**Town of Kittery
Planning Board Meeting
November 17, 2016**

450 U.S. Route 1 – Site Plan Review

Staff Review

From: Jodie Bray Strickland <jstrickland@cmaengineers.com>
Sent: Wednesday, November 09, 2016 4:44 PM
To: Chris DiMatteo; William Straub
Cc: Rebecca Spitko
Subject: RE: 450 US rt 1 (dominos)

Sheet:
C-1

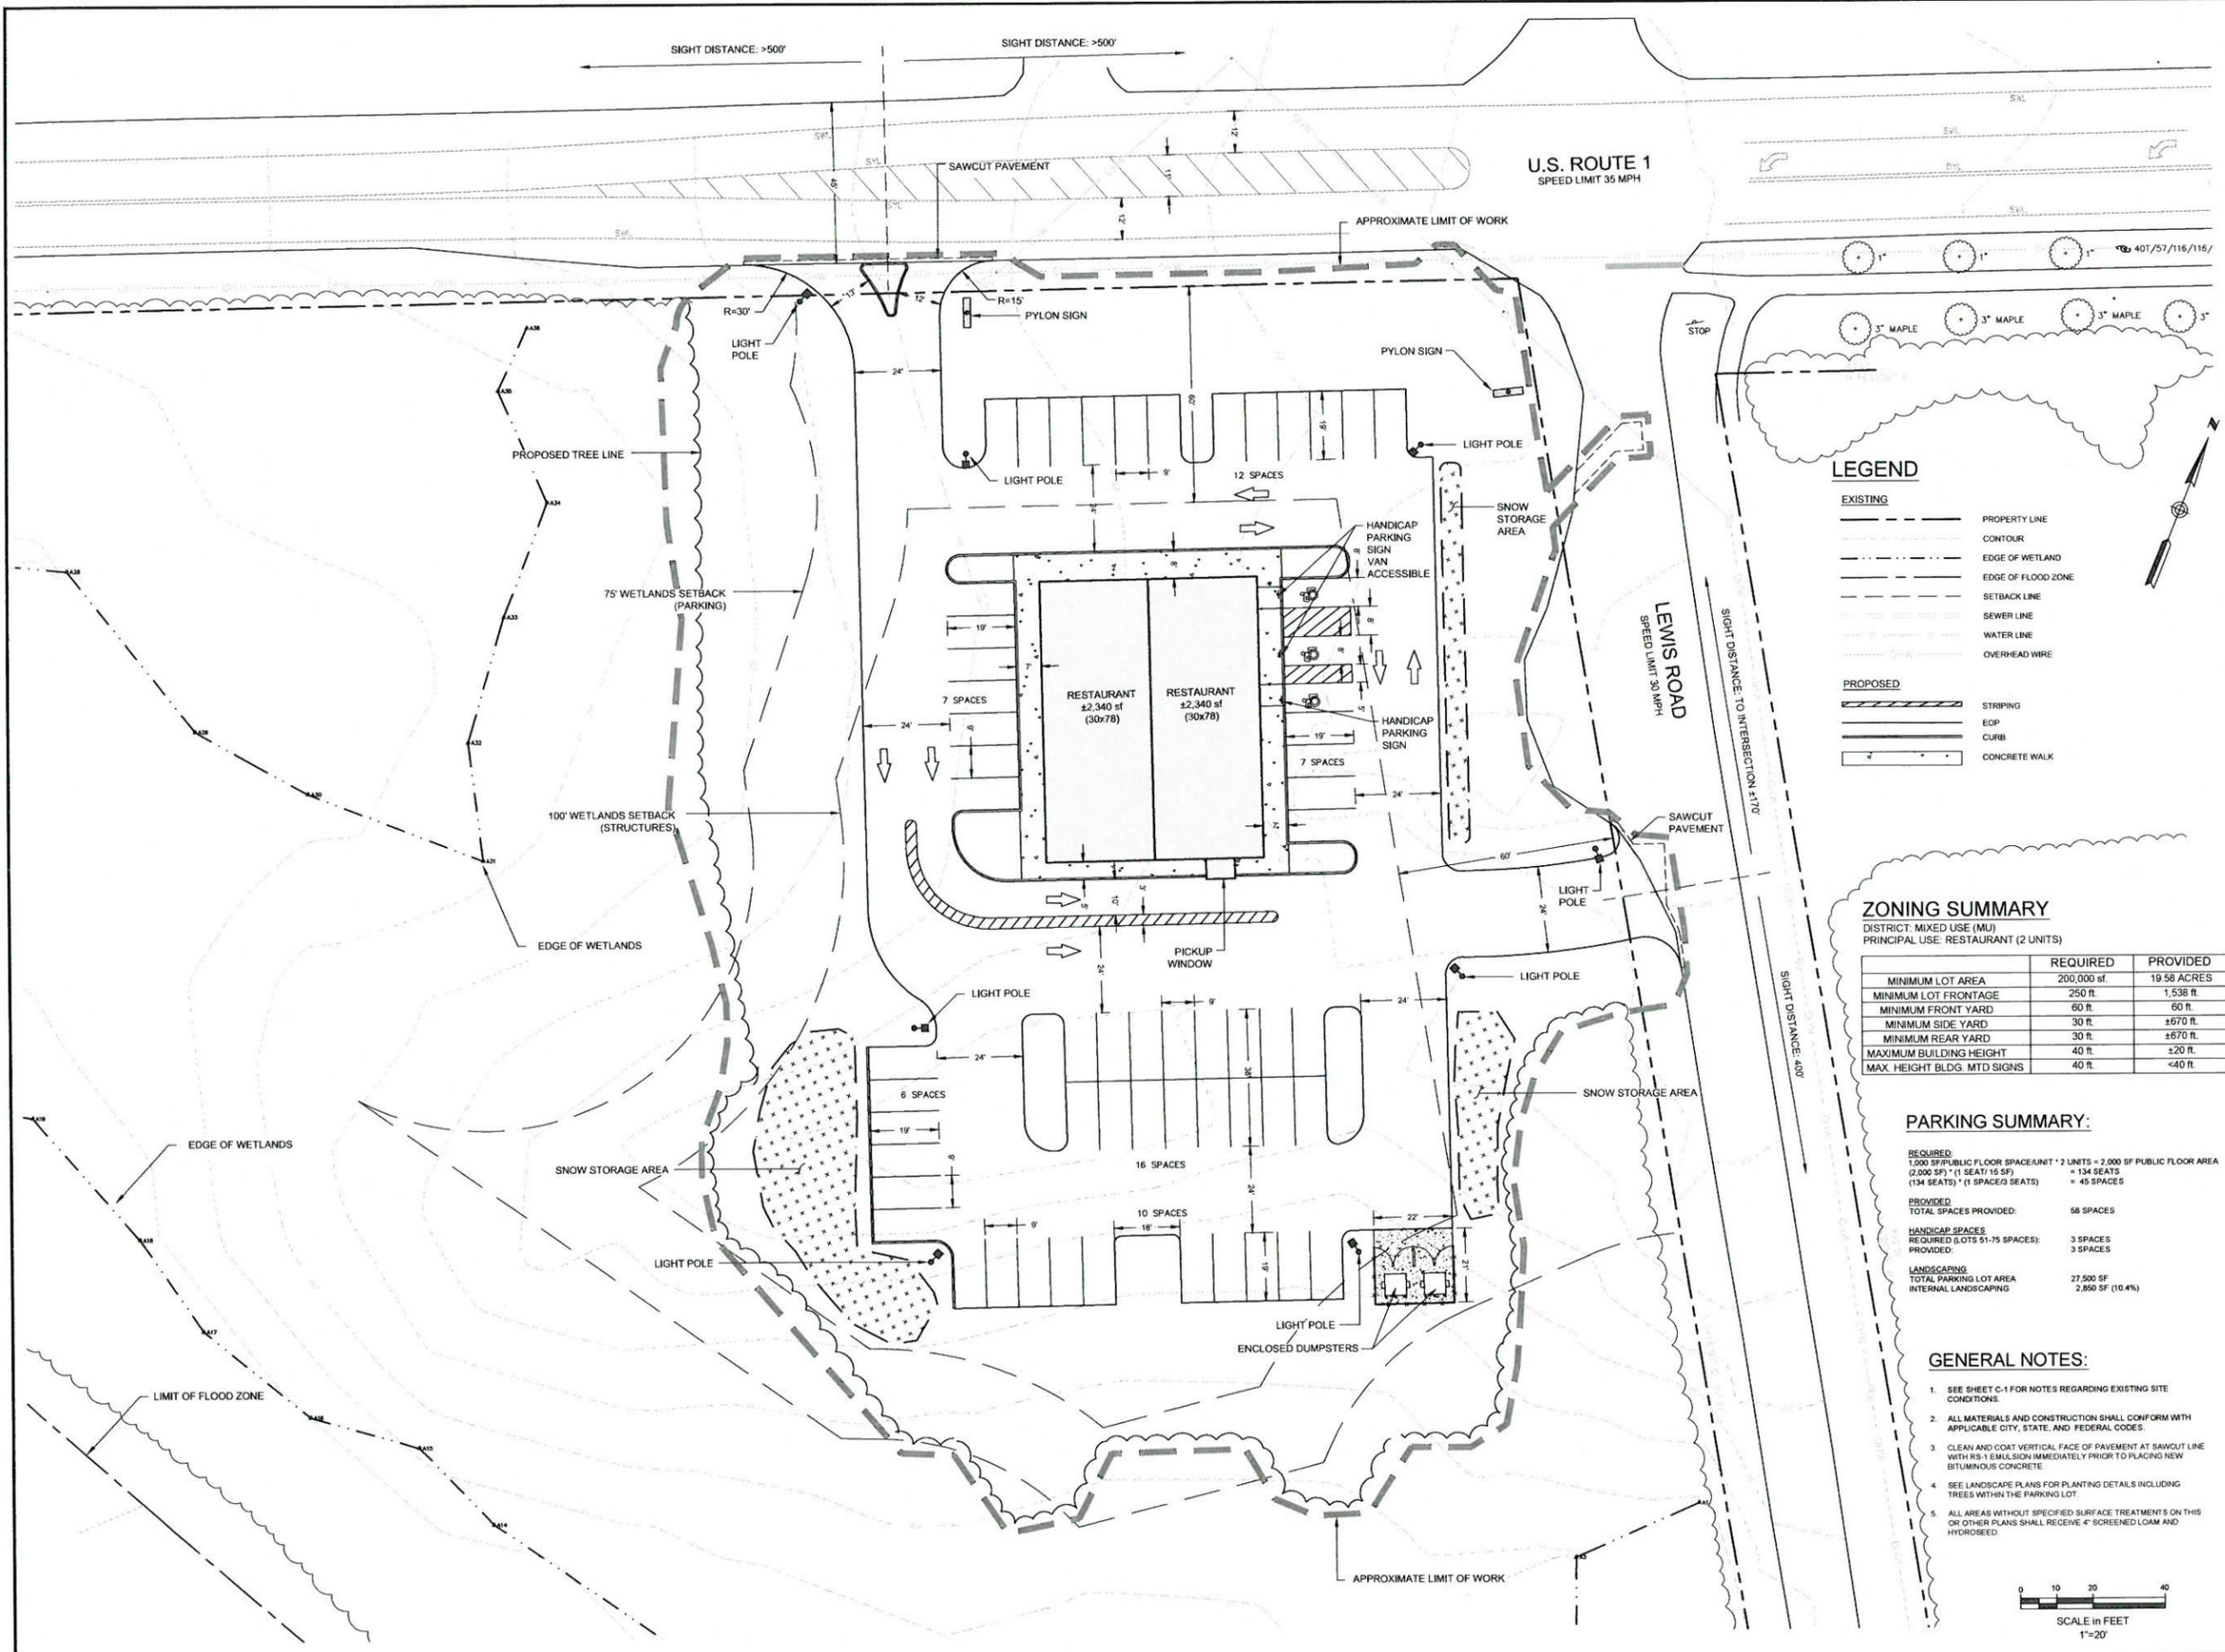
4. There are several large wetlands located on the property. The applicant has submitted a boundary survey dated 2/24/2014 with approximate wetland delineation. Wetland boundaries depicted on existing conditions plan (C-1) were delineated on 6/19/2016, therefore the setbacks depicted in relation to the proposed development are confirmed. All proposed structures are outside of the required wetland setbacks.

Sheet:
C-2

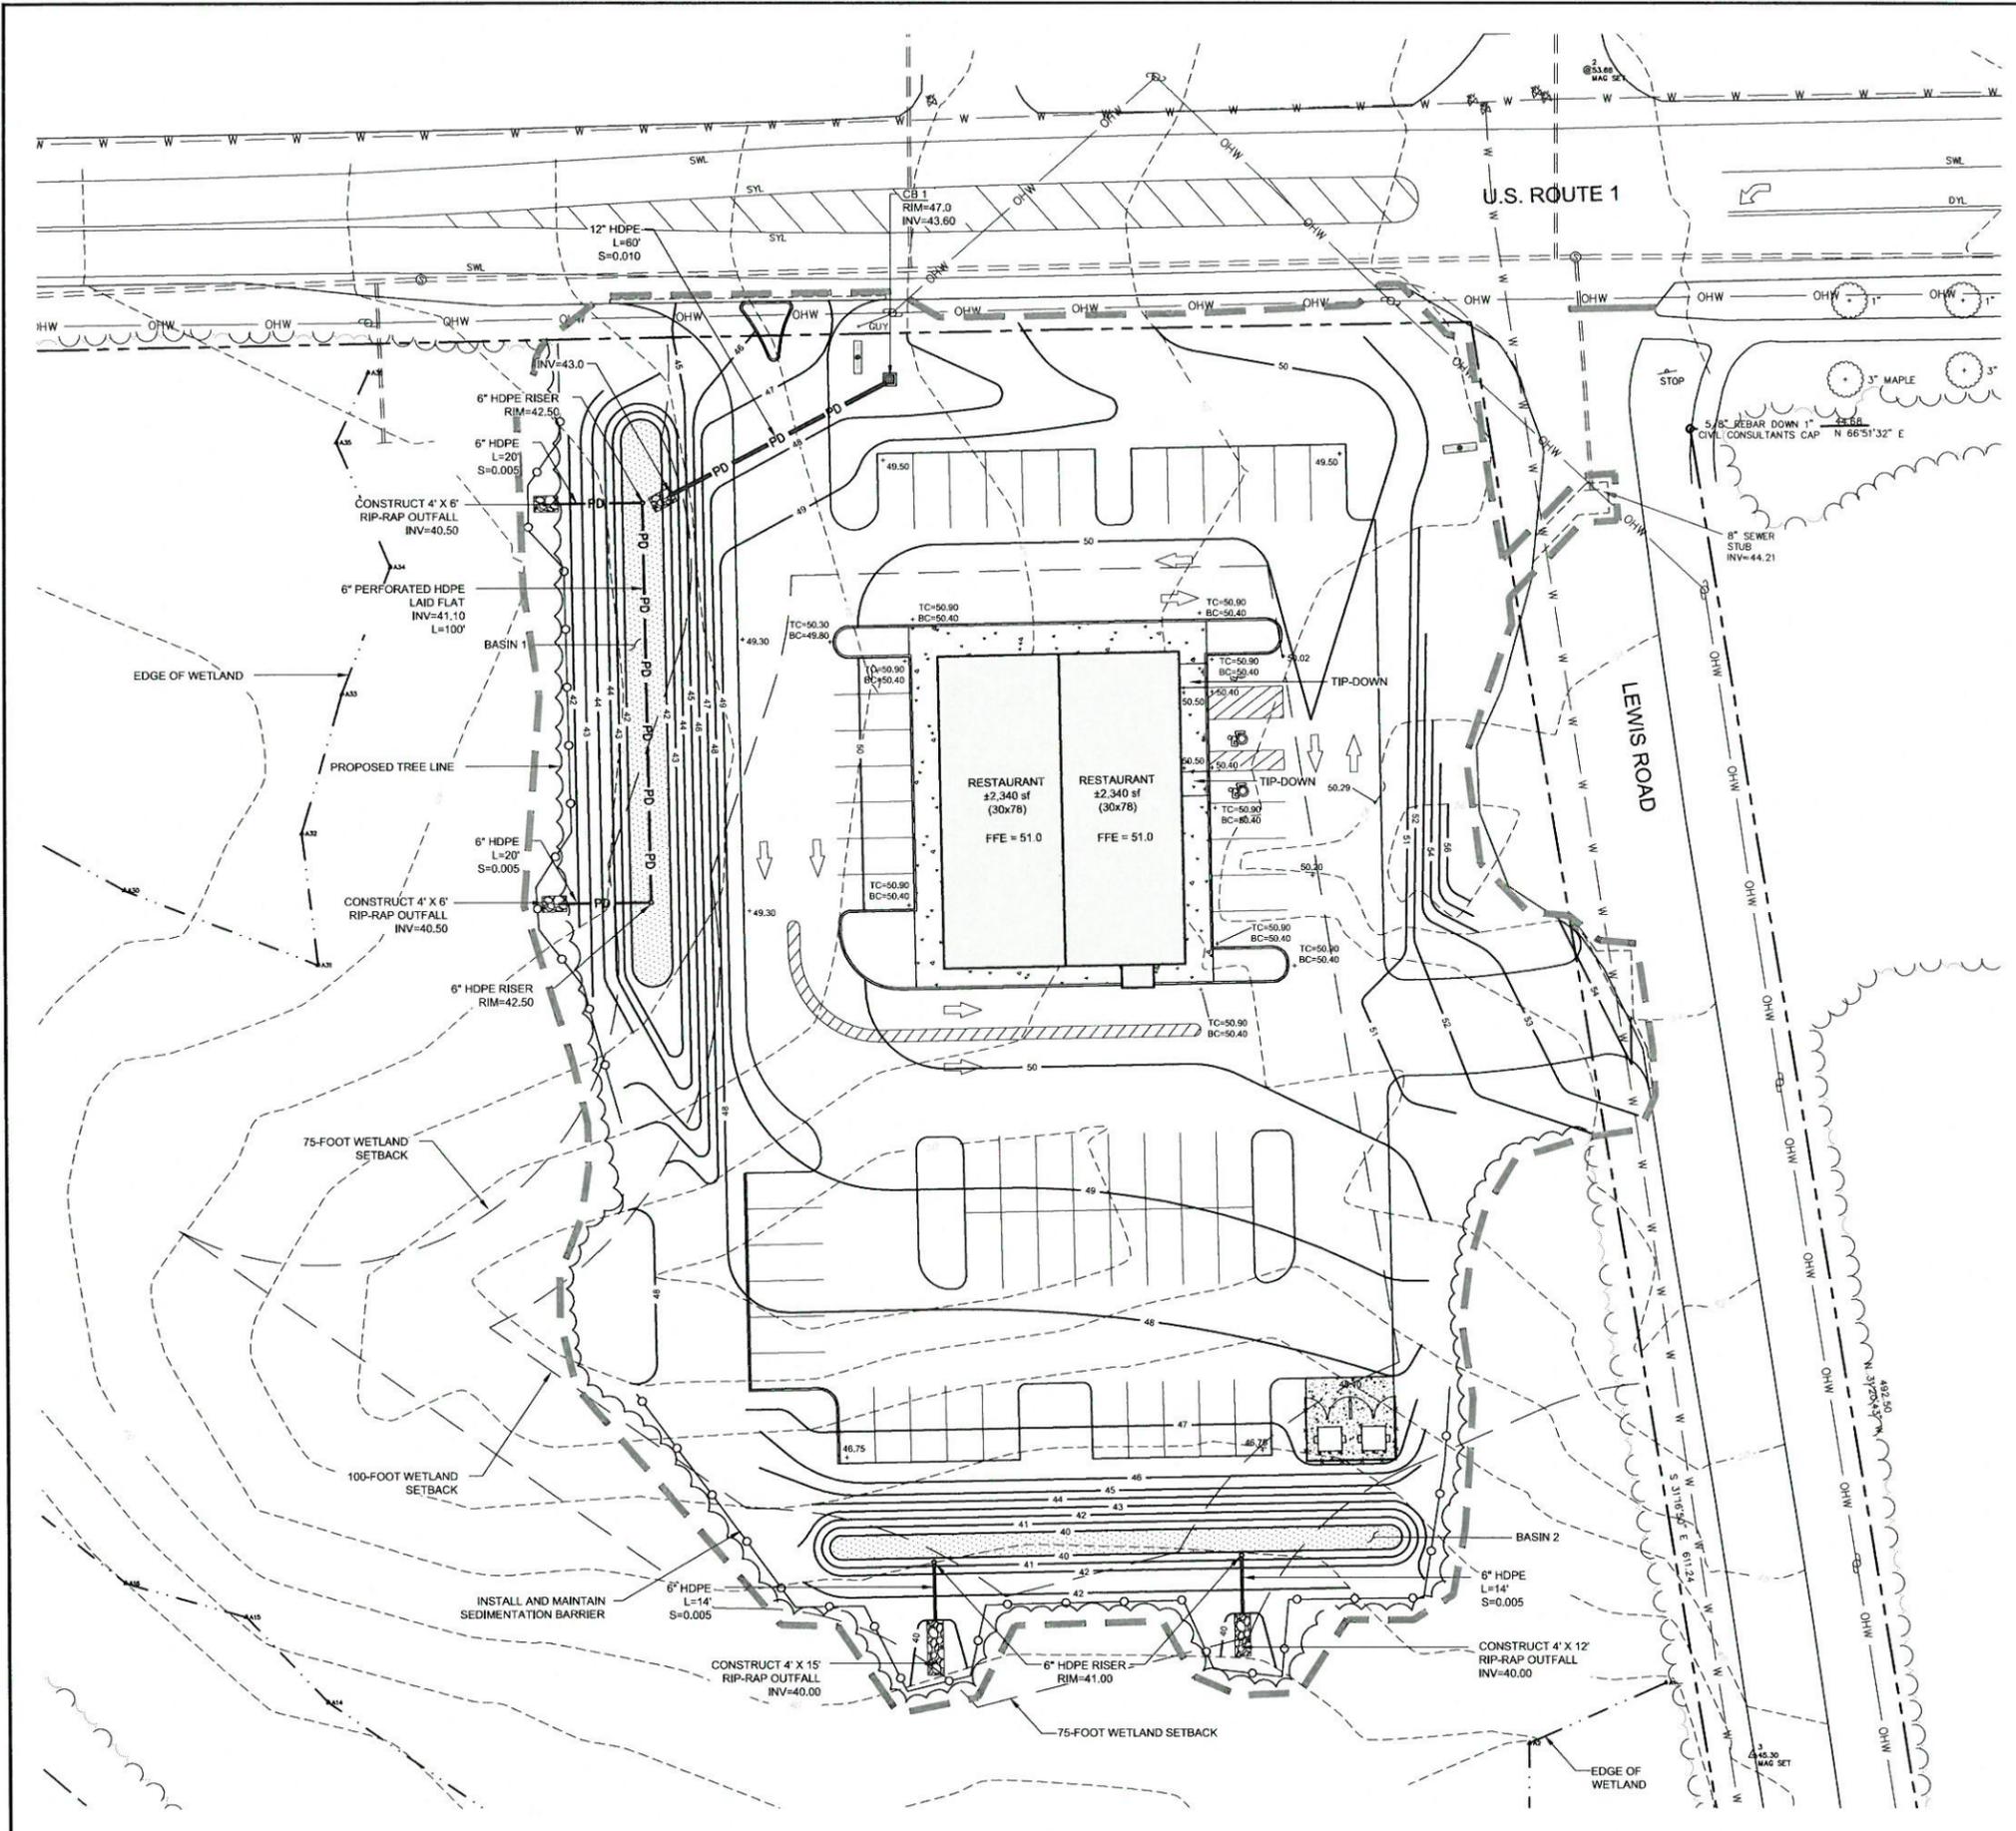
5. The site plan depicts 58 parking spots. Required off-street parking standards for restaurants is 1 parking space for each three seats, with seating calculated by dividing the total floor area with customer access by 15. Site layout plan C-2 depicts each of the two restaurants will have 1,000 square feet of customer access. A floor plan to support that amount of customer access has not been submitted. Required spaces is a total of 44 $((2,000/15=133.33)/3=44.44$ or 44 spaces). In addition, the proposed Domino's Pizza incorporates a drive-thru pick up window. The required parking for a drive-in restaurant, snack bar and fast food outlets are a minimum of 15 parking spaces, plus 1 space for each three seats, calculated in the same manner described above. The proposed number of spaces almost accommodates the additional 15 spaces. The Board should determine if the "pick-up" window should be considered as a traditional "drive-thru" subject to the additional 15 spaces.

6. All parking must be located at the side or rear of principal buildings, with the exception of 10 (or fewer) spaces, which may be located closer to the front lot line than the principal building. The site plan depicts 12 parking spaces between the principal building and the lot line. The plan needs to be revised to conform to 16.3.2.13.D.4 Location and screening of parking areas. No waiver can be given.

8. Plan C-2 depicts three areas for snow removal/storage on the site.
9. A wall may not extend for a length of more than 50-feet without an architectural feature (dormer, cornice, window, etc.). The design sketches submitted by Jason D Gnich Architect are not shown to scale, however the rear and southwesterly side of the building appear to have a large blank wall along approximately half the building. The applicant needs to redesign this portion of the building to avoid a *featureless wall* as stipulated in 16.3.2.13.D.5 Building Design Standards.

- D.2. The provided side yard dimension of +/-670 feet on sheet C-2 does not appear to be correct.
- D.6.a. It is not clear that the landscape planter strip is the proper size.

The existing and proposed conditions at the entrance on Lewis Road are confusing and do not show the actual alignment of Lewis Road. Please clarify.

The entrance/exit on US Route One should be labeled with signage and pavement markings. Are turning movements in both directions on US Route One proposed?

Is the entrance on Lewis Road proposed to be one way?

1. Revise the plan to depict 10 or fewer spaces between the principal building and front lot line.
2. Revise the landscape plan to conform with the design standards.
3. Relocate the sign currently located at the corner of Lewis Road and Route 1.
